POLICY REPORT DEVELOPMENT AND BUILDING

TO: Vancouver City Council
FROM: General Manager of Planning and Development Services
SUBJECT: CD-1 Rezoning - 1041 SW Marine Drive

1041 SW Marine Drive
DRAFT AMENDMENTS TO CD-1 (276) BY-LAW NO. 6876

1041 SW Marine Drive
PROPOSED CONDITIONS OF APPROVAL

Figure 1.

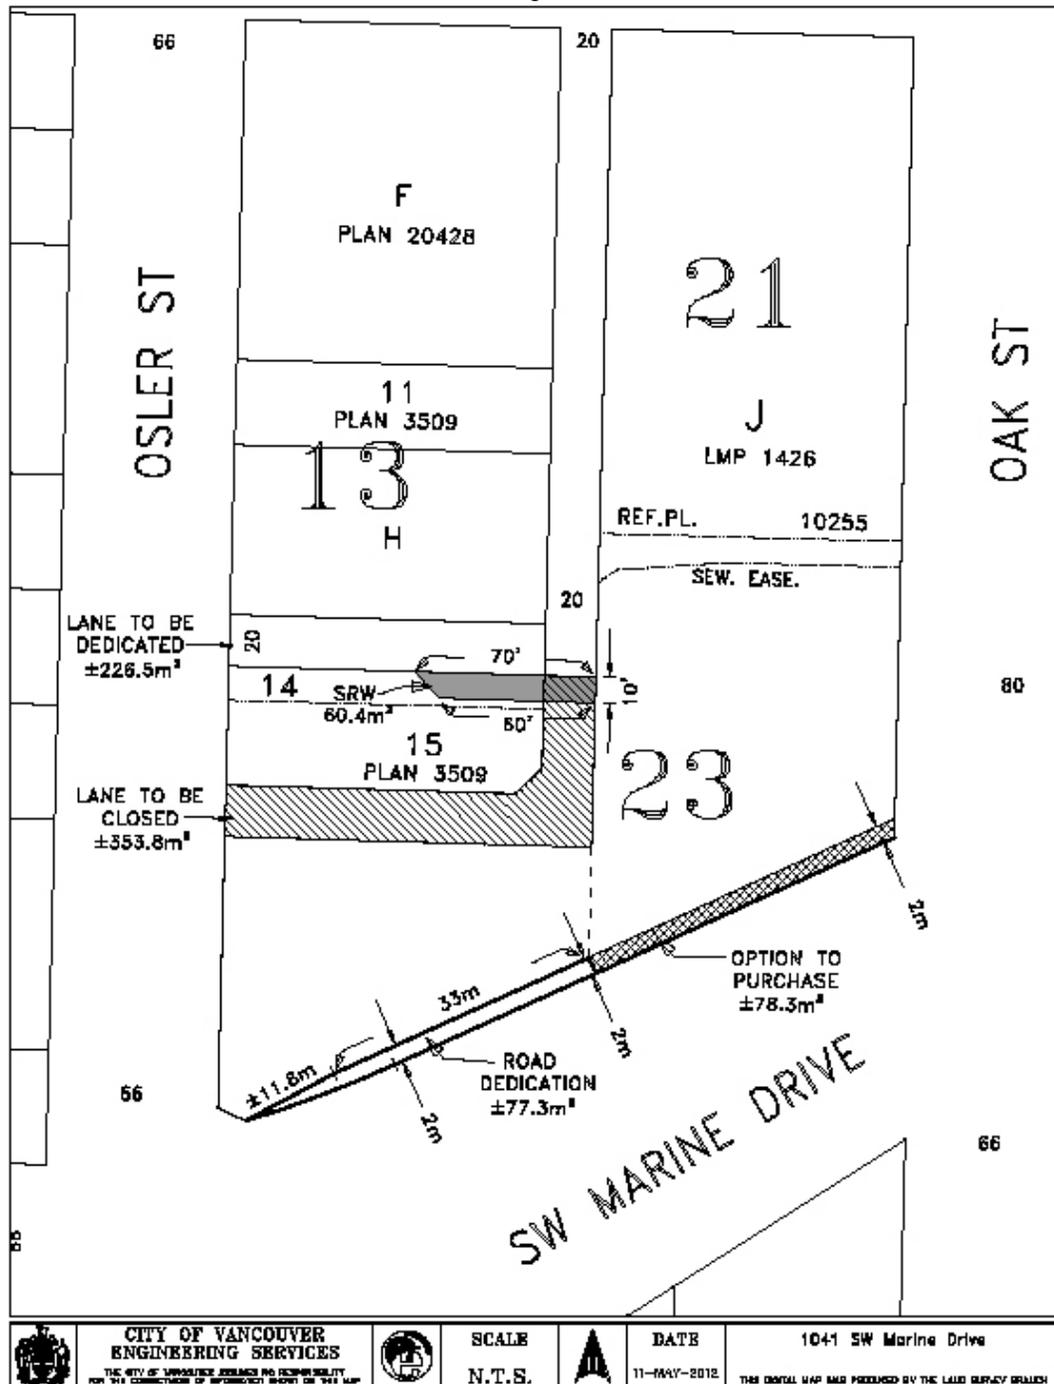
3. Subdivision of the site to accomplish the following:
 - (i) the consolidation of Lot 14, Lot 15, Lot J, and the closed lane (referred to in condition 2 above) to form a single parcel;
 - (ii) the dedication as lane of the north 20 feet of Lot 14 (see figure 1 Appendix B);
 - (iii) the dedication as road of a corner truncation and 2.0 m widening along SW Marine Drive as generally shown in Figure 1 (Appendix B);

4. Provision of an Option to Purchase in favour of the City for the future 2.0 m widening of SW Marine Drive east of the 2.0 m dedication as shown in Figure 1 (Appendix B).

5. Provision of a Statutory Right of Way for the lane turning bulge along the south side of the new east-west lane as shown in Figure 1.

Note: Within the turning-bulge area a minimum clear height of 15 feet above grade must be provided and the sub-surface structure must meet or exceed loading requirements to CL-625 and BC-625 (higher axle load) as per CHBDC-S6-06 (Canadian Bridge Code) and BC Supplement. If a lane dedication from off-site Lot H Block 13 of Block C District Lots 319, 323, and 324 Plan 20910 can be facilitated by the applicant the turning-bulge Statutory Right of Way in the lane will not be required.

Applicants schematic drawings and notes explaining intended changes to accommodate the sidewalk expansion

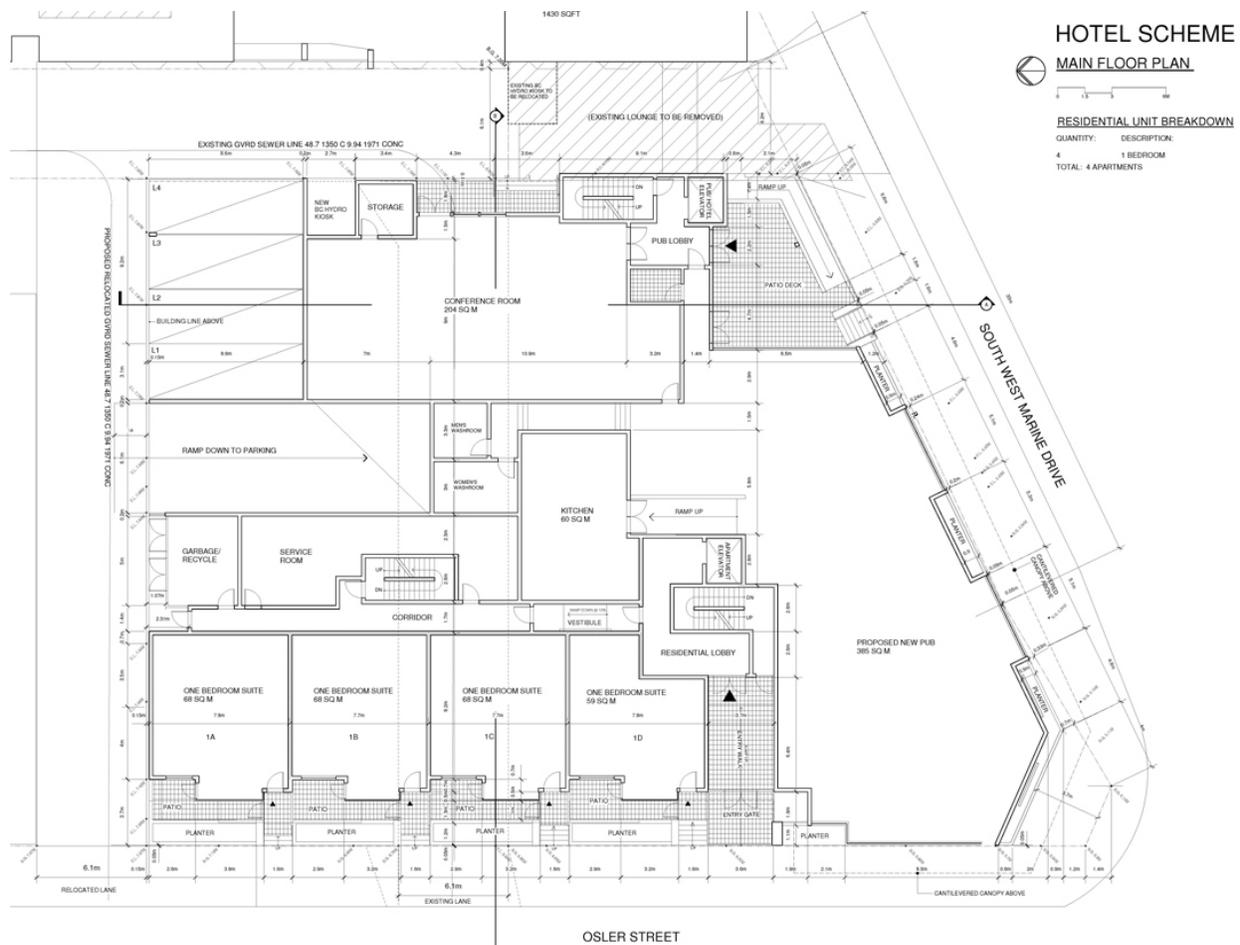
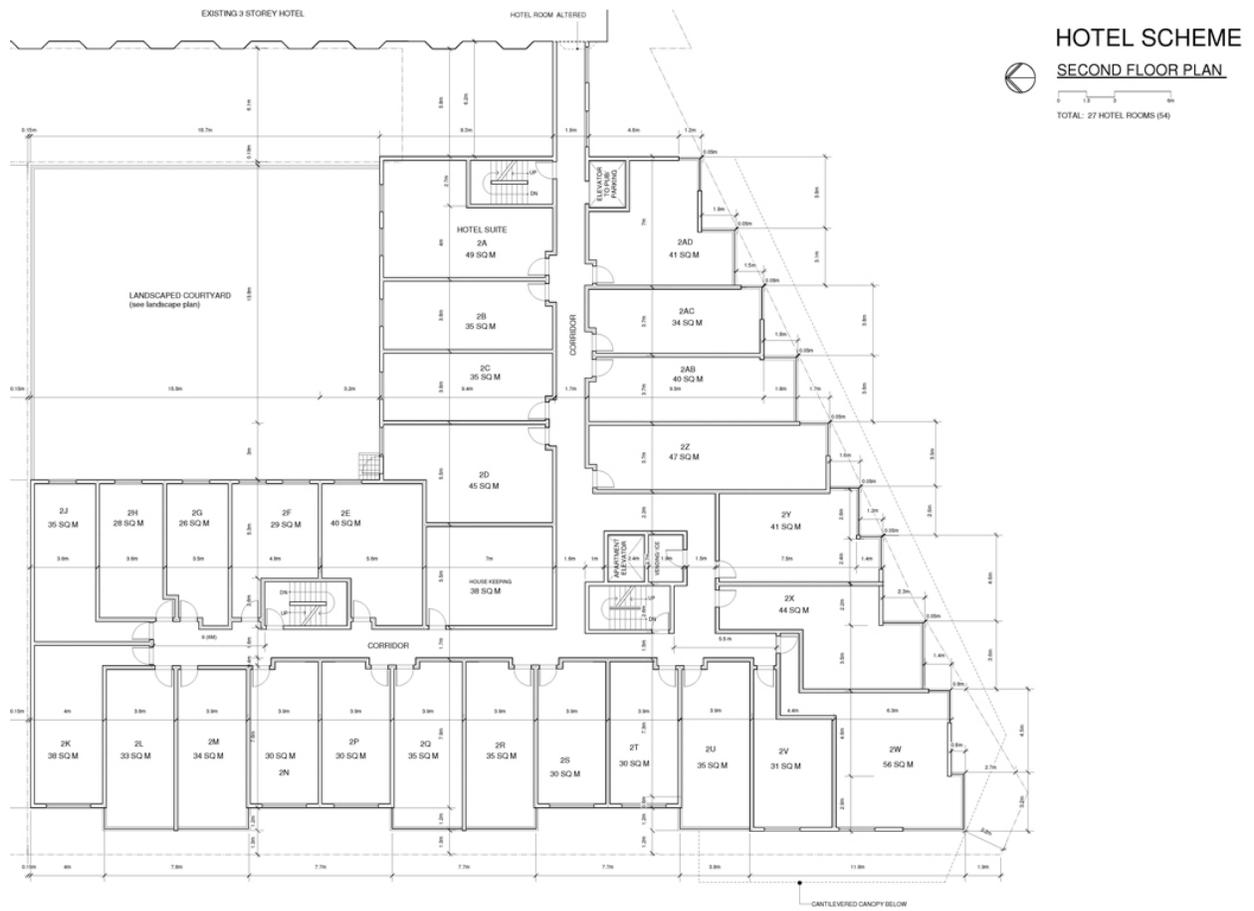
General changes made to the proposed building in order to fit the road dedication:

- North-west corner - Landscaping (on north side only) and exit stair from the parkade have been removed (stair to be relocated within).
- The entire building was shifted 2 meters in the North direction.
- Moreover, the south elevation was pushed even farther North to keep it within new PL without changing profile of the facade.
- Modifications to Conference Room and Pub - Exterior/interior walls shifted to accommodate loading bays and in response to lost floor space.
- South-east corner - entry patio deck size further reduced to keep within new PL.
- East elevation - planter at main floor level has been eliminated.
- 5th & 6th Floors - Units 5E/6E, 5G/6F have been modestly expanded to recuperate some of the lost floor space.
